Brewhouse Part VIII Amendments

Proposed Part VIII Amendments

October 2017

P114-215K Brewhouse

PROPOSED LIFT LOCATION IN EXISTING SEMI BASEMENT

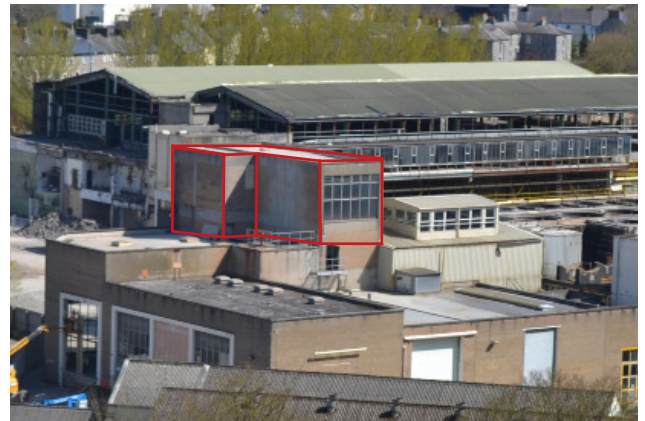
During detailed design, various consultations were undertaken with Colm Flynn, Archaeologist. These design workshops indicated archaeologically sensitive areas and further design workshops changed the initial design to reduce the archaeological impact of the renovation. One area of change included the relocation of the lift core into an existing semi basement. This changes avoided the need for excavation to accommodate the lifts, thus reducing the potential impact on archaeology in the area. The revised location of the lift core resulted in alterations to the roof scape and allowed for the existing plant room to revert its original 'L' shape profile.

Current Phasing Plan

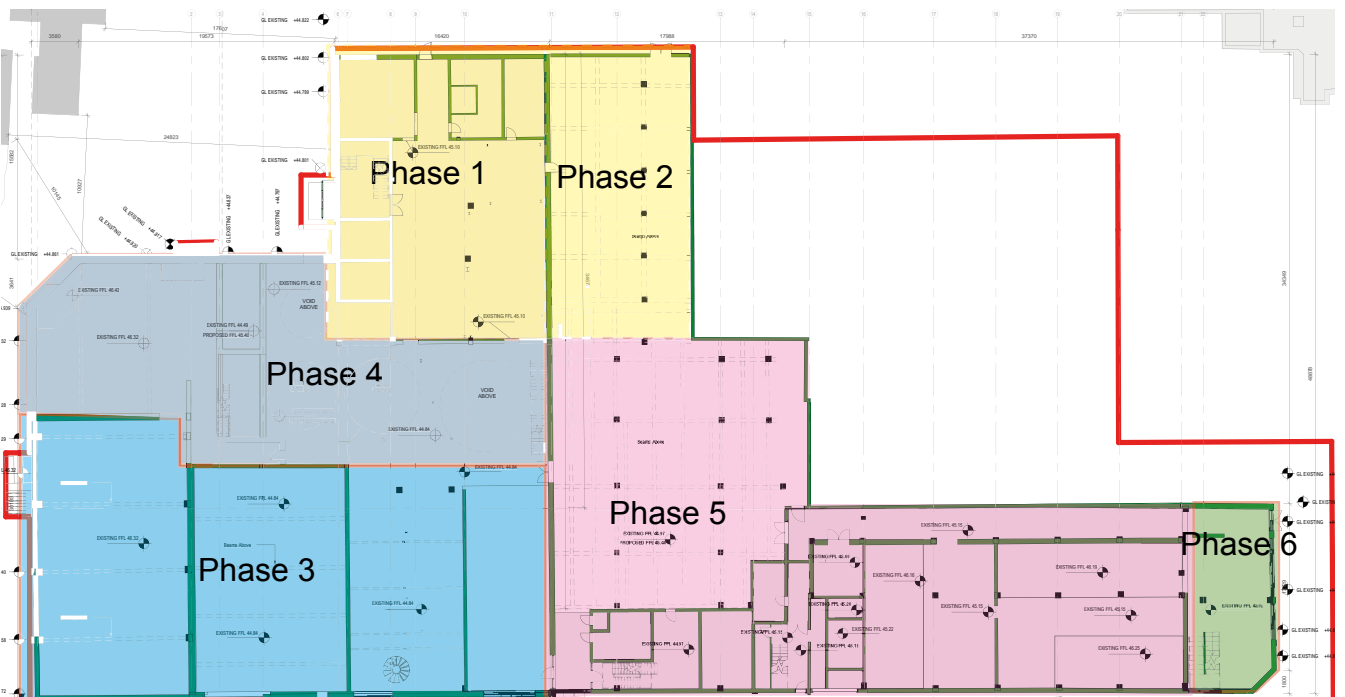
The understanding of the phasing of the building has developed due to new information coming to light and from more detailed building investigations, and are set out in the diagrams below.

there was no rooftop access from the main stair in the Phase 1 building, and photographs demonstrate that the rooftop railing on the north elevation of Phase 1 is an addition that did not form part of the original design intent.

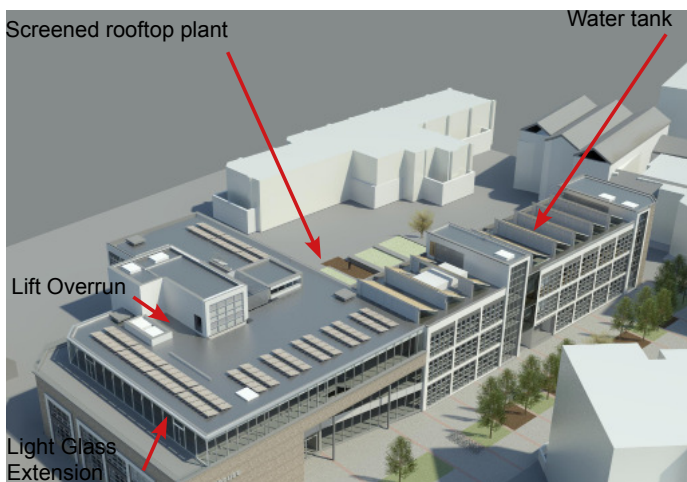
Subsequent to the removal of brewery structures and resurvey, it became apparent that the heights of the various parapets across the-building have changed. It is now intended that the parapet heights are all raised to the existing higher level, and are consistent. The increase will create a clear form. The towers will be clearly delineated from the building in height and through horizontal expression at junctions. The central tower will be circa 3.5m above the parapet height and the souther tower will be circa 1.8m above the parapet. The expression of theses towers has been considered an important feature in retaining the buildings character.

PROPOSED AMENDMENTS GROUND FLOOR

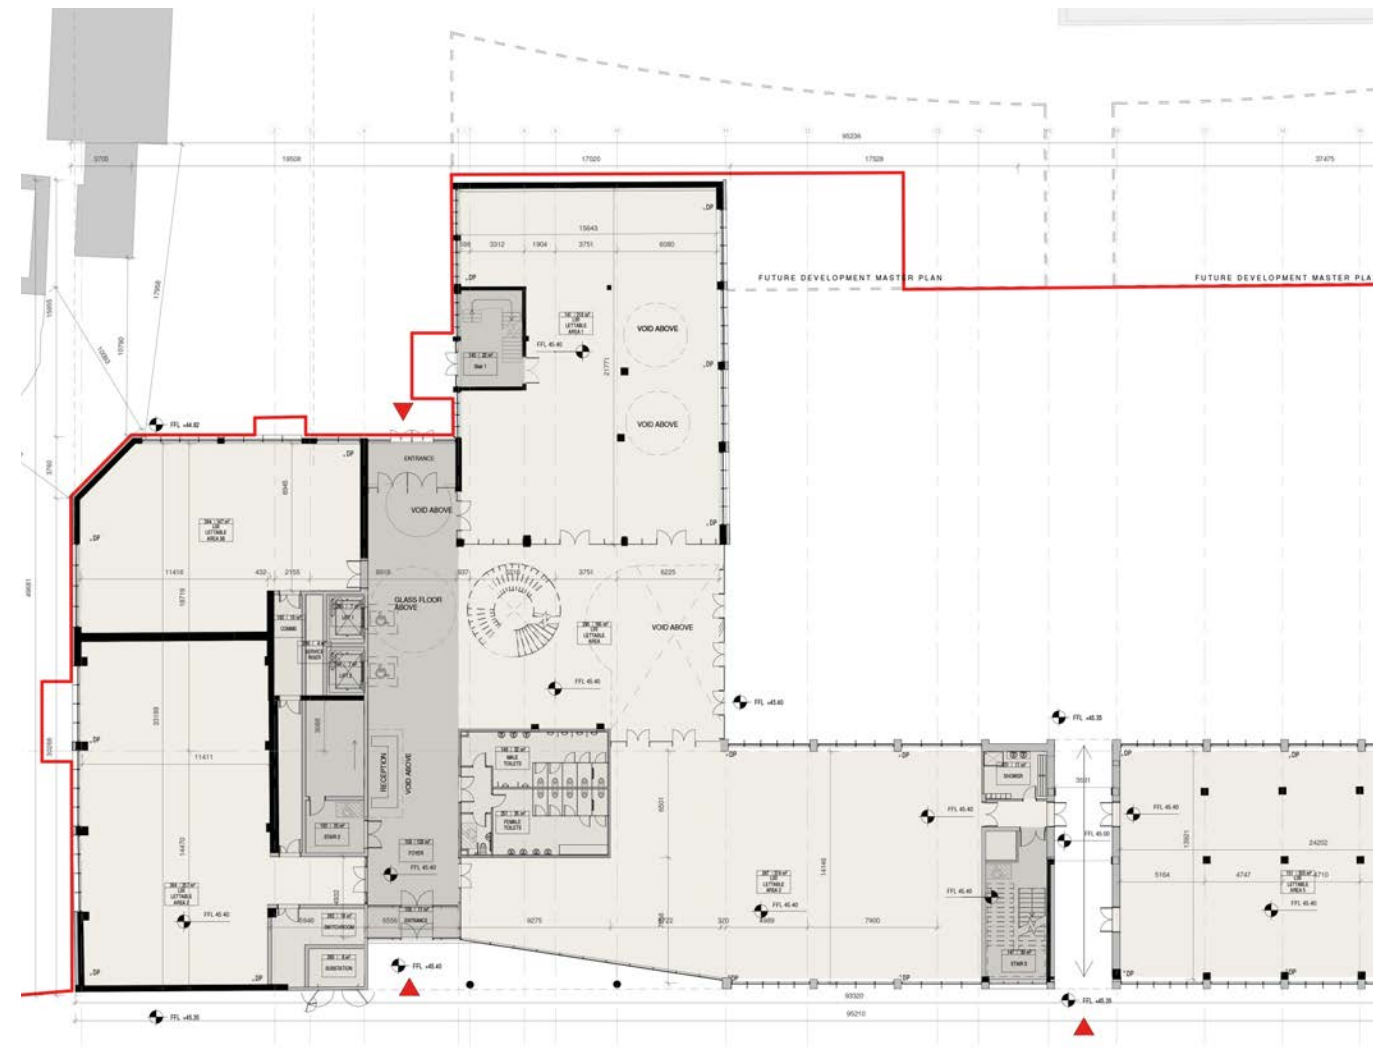
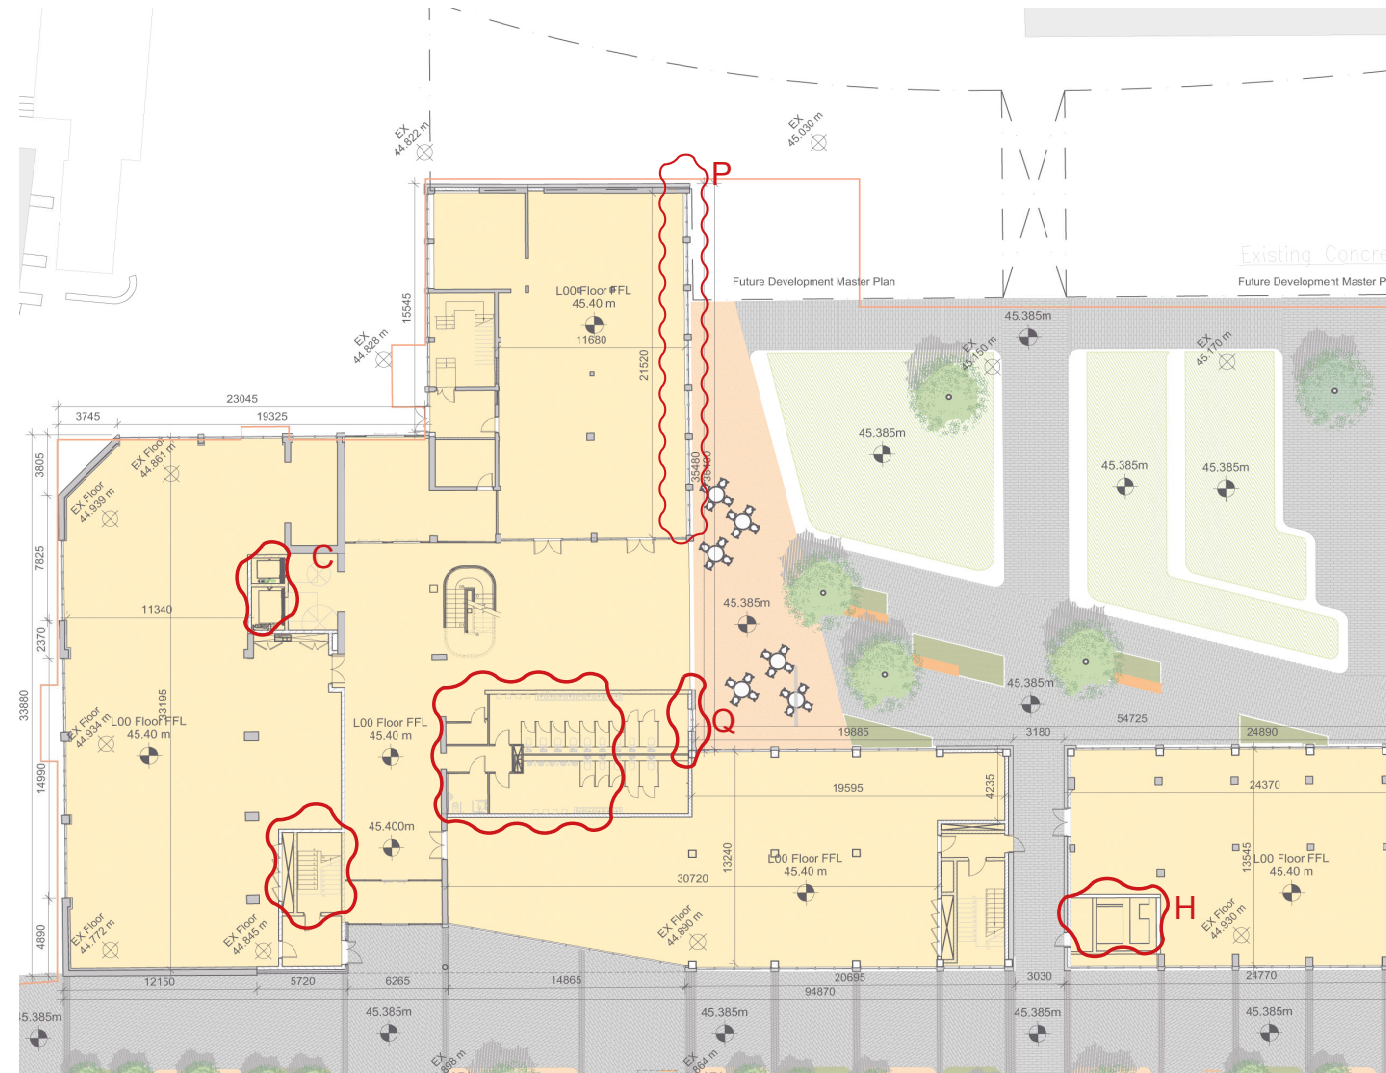
| <ul style="list-style-type: none"> A. Roof Heights and Levels Modified. B. Balcony Modified, Roof Overhang Omitted. C. Lift Moved to New Location. D. Existing 'L' profile of Plantroom Reinstalled. E. Platform to Accommodate Equipment, Screened with Metal Cladding. F. Roof Light Modified. G. Sawtooth Roof Modified. H. ESB Substation Relocated. Bay Recessed 1m into Facade. J. External Landscape Levels Modified. | <ul style="list-style-type: none"> K. Window Removed. L. Door added. M. Existing Floor Retained. Floor Level Modified. N. Water Tank Screened Behind Sawtooth Roof Structure. P. Facade Updated to Reflect Existing Column Grid Structure. Q. Facade Updated to Reflect Internal WC Core Modifications. R. External Balcony Modified. |

PROPOSED AMENDMENTS TO WEST ELEVATION

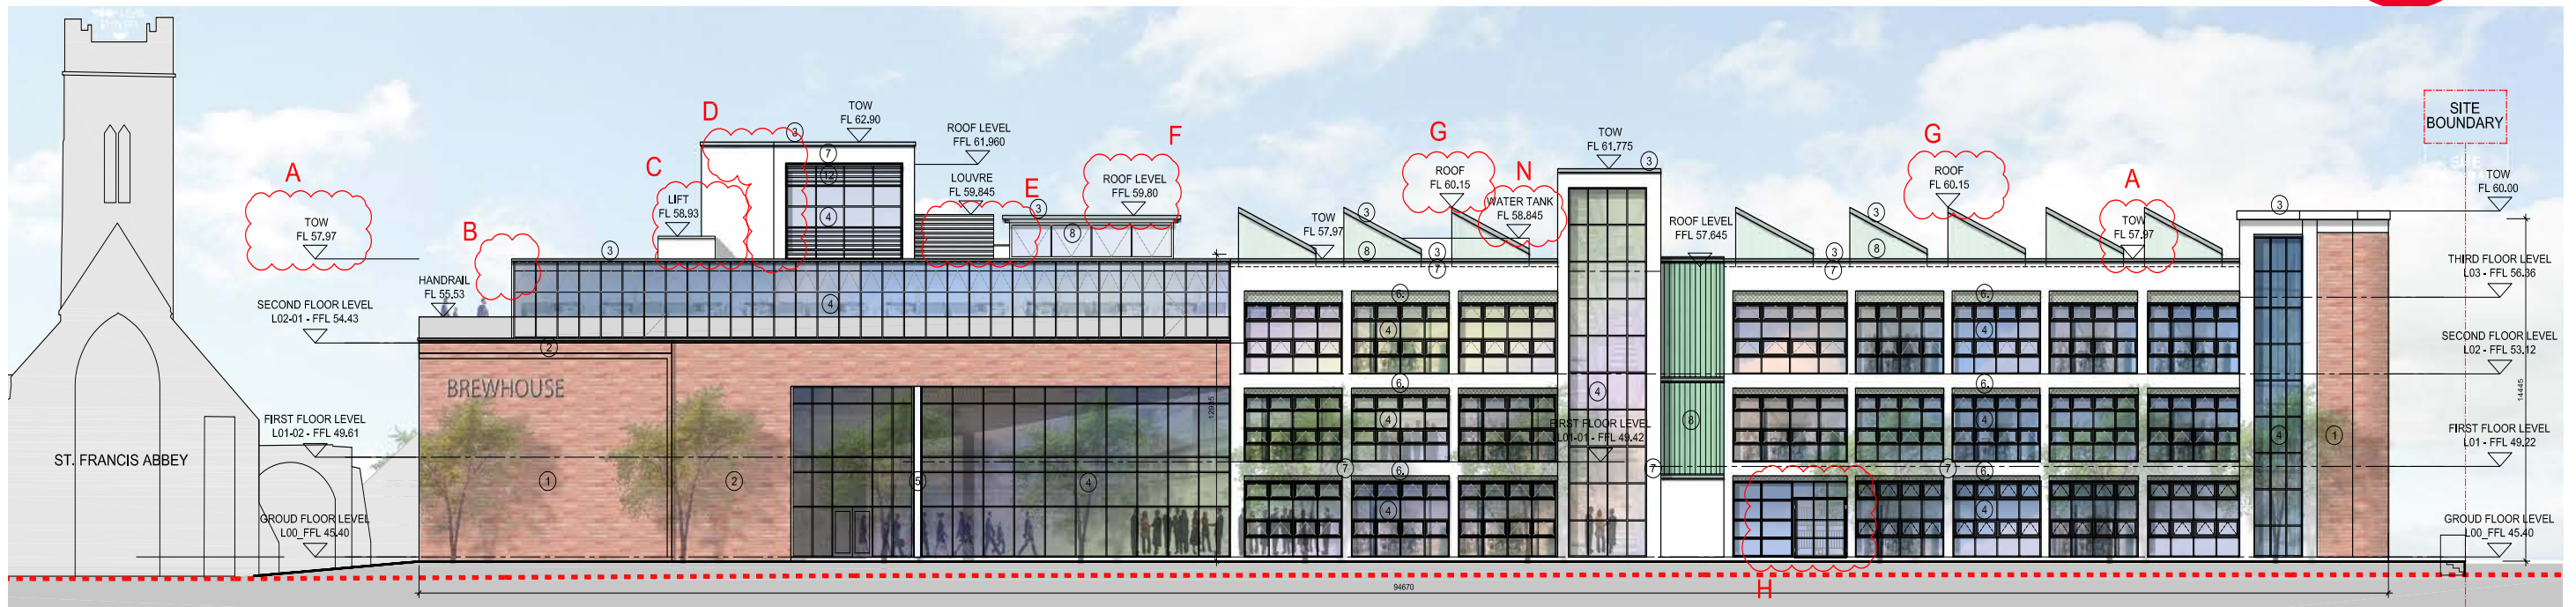
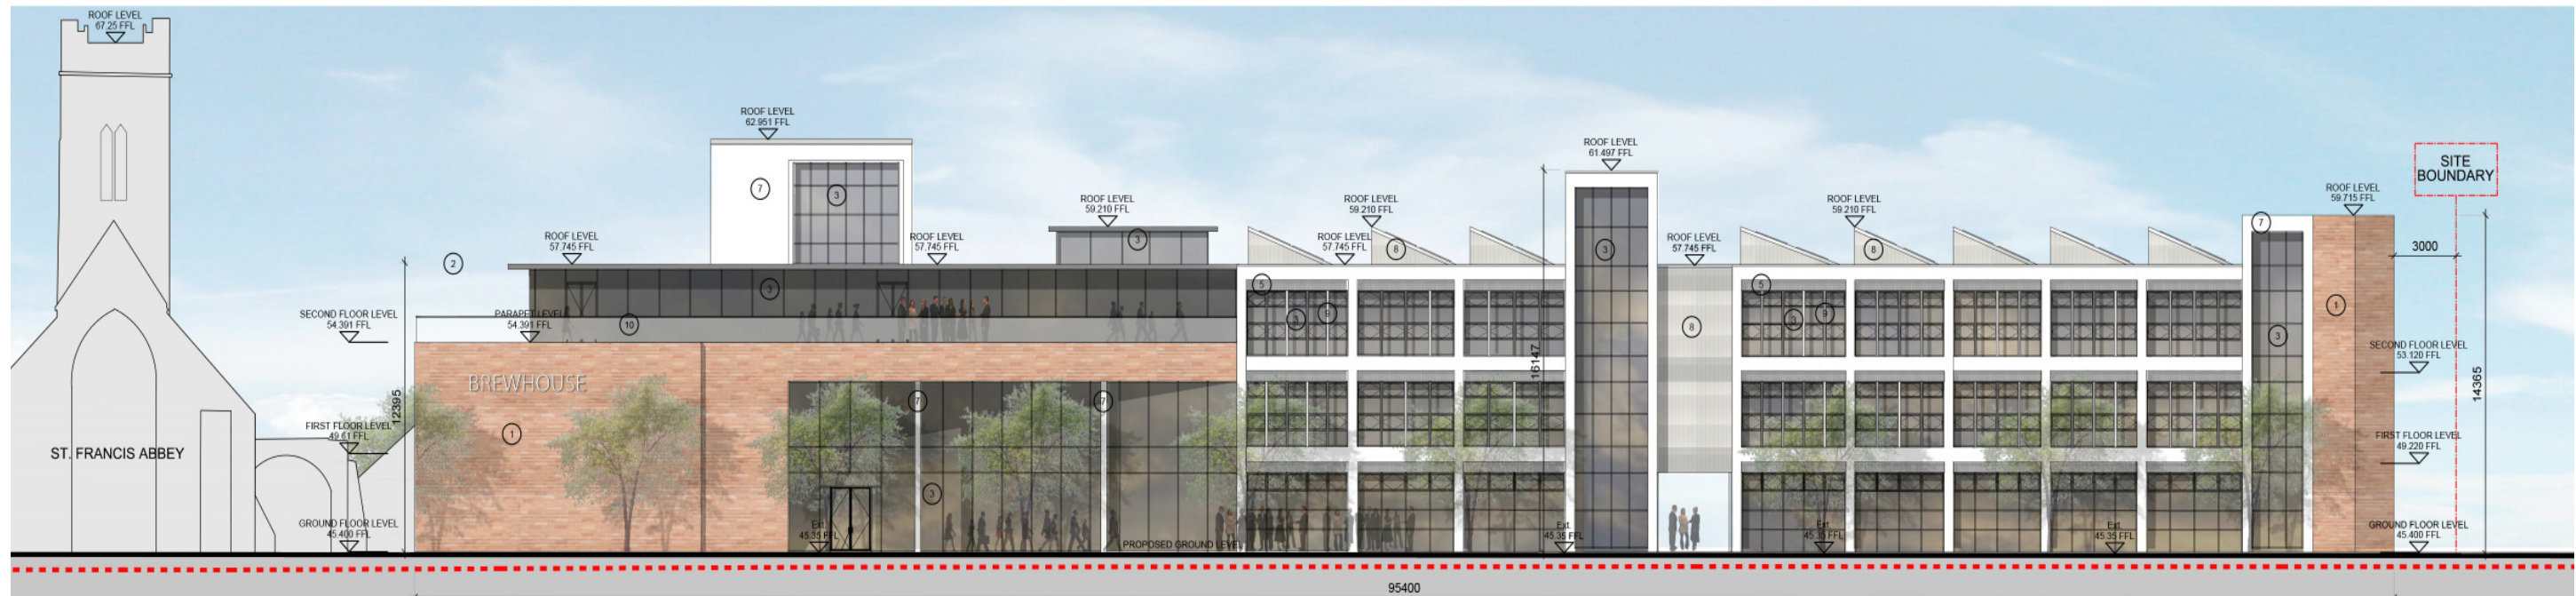
- A. Roof Heights and Levels Modified.
- B. Balcony Modified, Roof Overhang Omitted.
- C. Lift Moved to New Location.
- D. Existing 'L' profile of Plantroom Reinstalled.
- E. Platform to Accommodate Equipment, Screened with Metal Cladding.
- F. Roof Light Modified.
- G. Sawtooth Roof Modified.

PROPOSED AMENDMENTS TO EAST ELEVATION

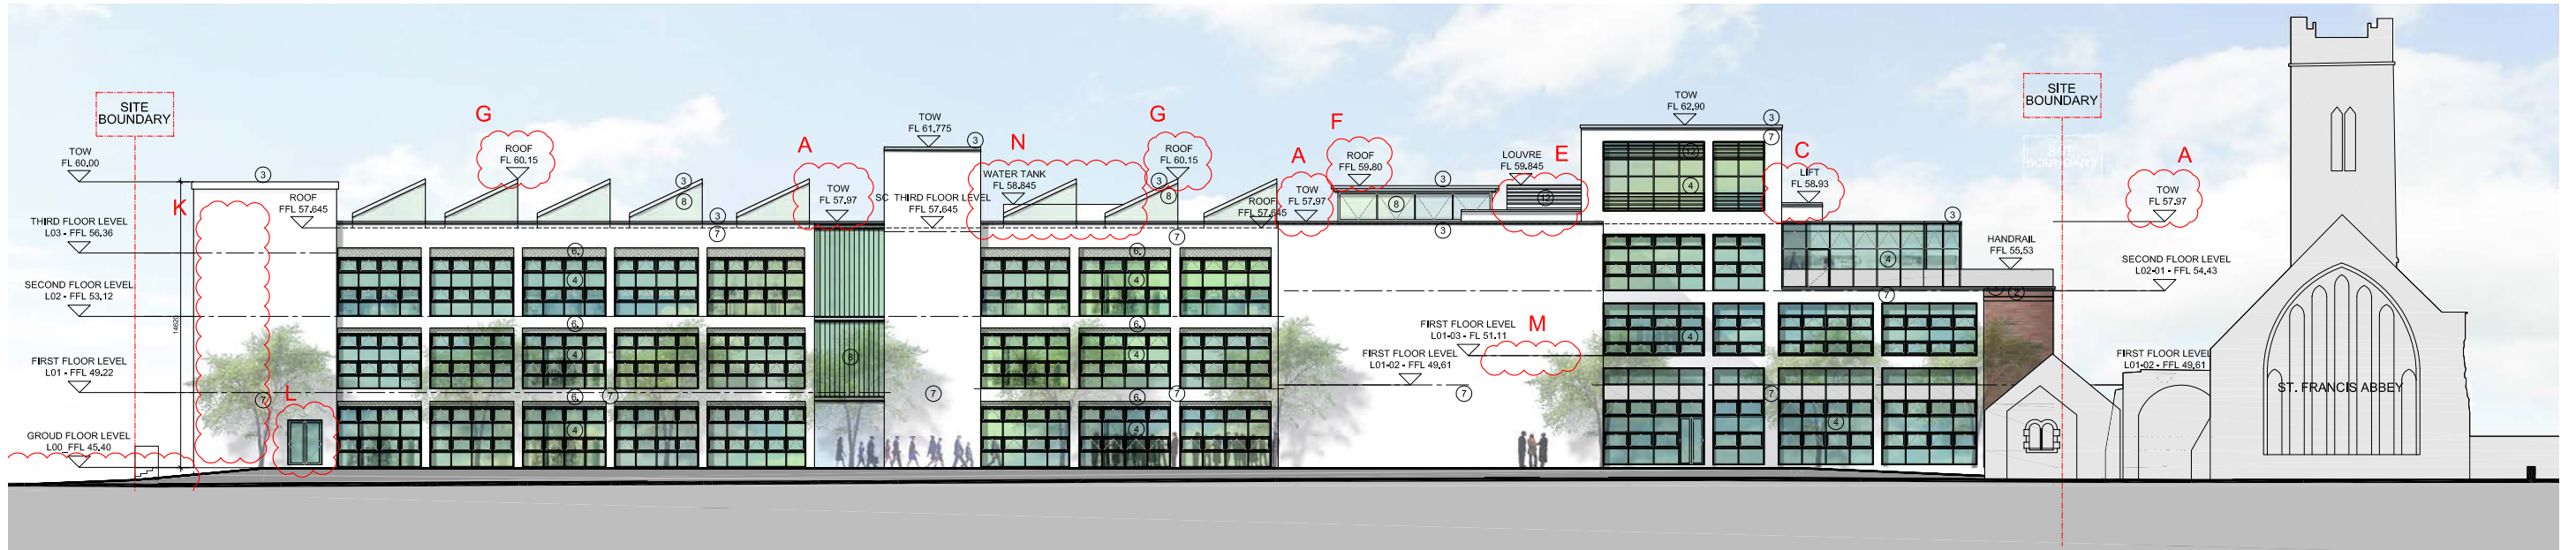
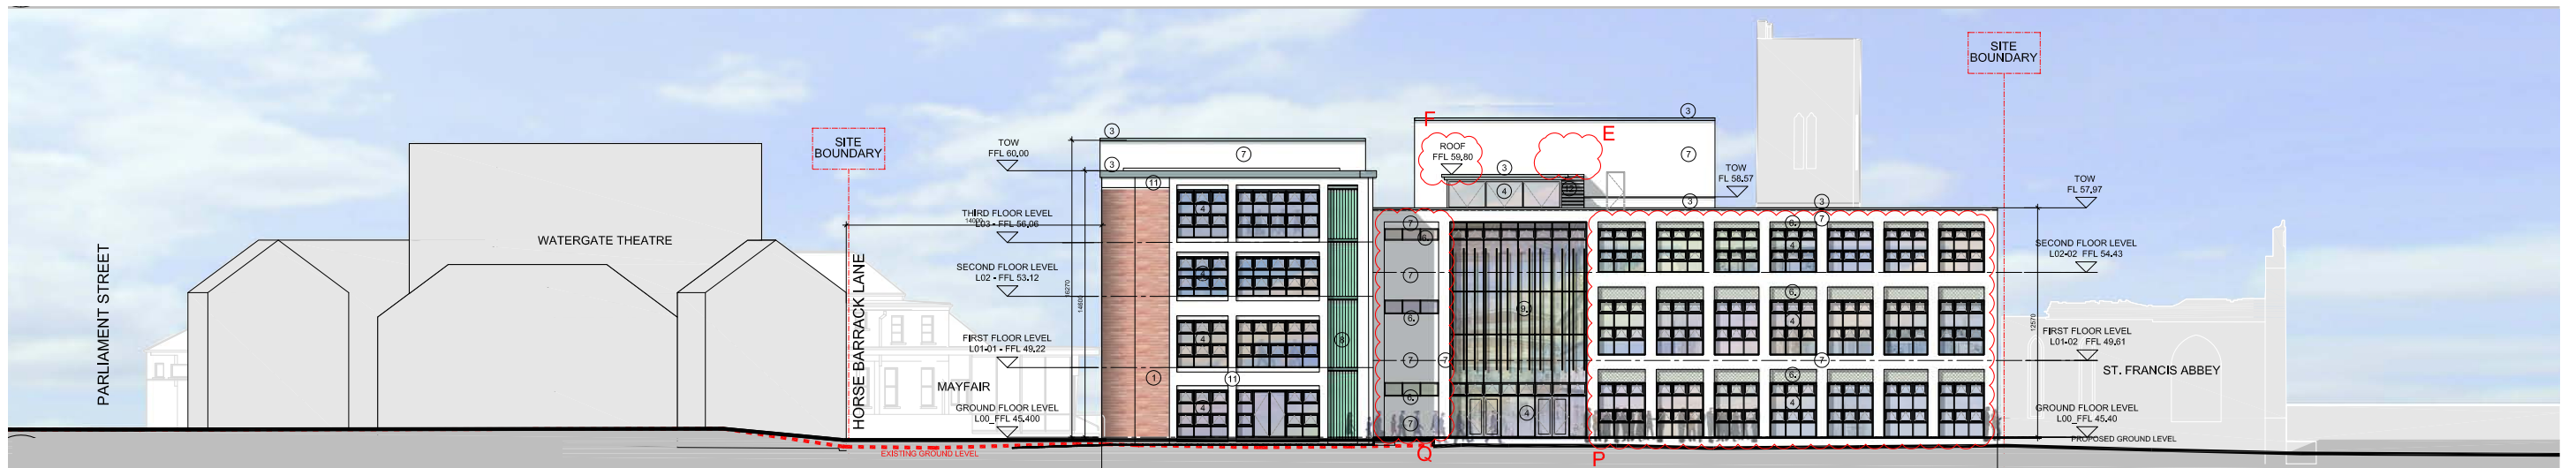
- H. ESB Substation Relocated. Bay Recessed 1m into Facade.
- J. External Landscape Levels Modified.
- K. Window Removed.
- L. Door added.
- M. Existing Floor Retained. Floor Level Modified.
- N. Water Tank Screened Behind Sawtooth Roof Structure.
- P. Facade Updated to Reflect Existing Column Grid Structure.
- Q. Facade Updated to Reflect Internal WC Core Modifications.
- R. External Balcony Modified.
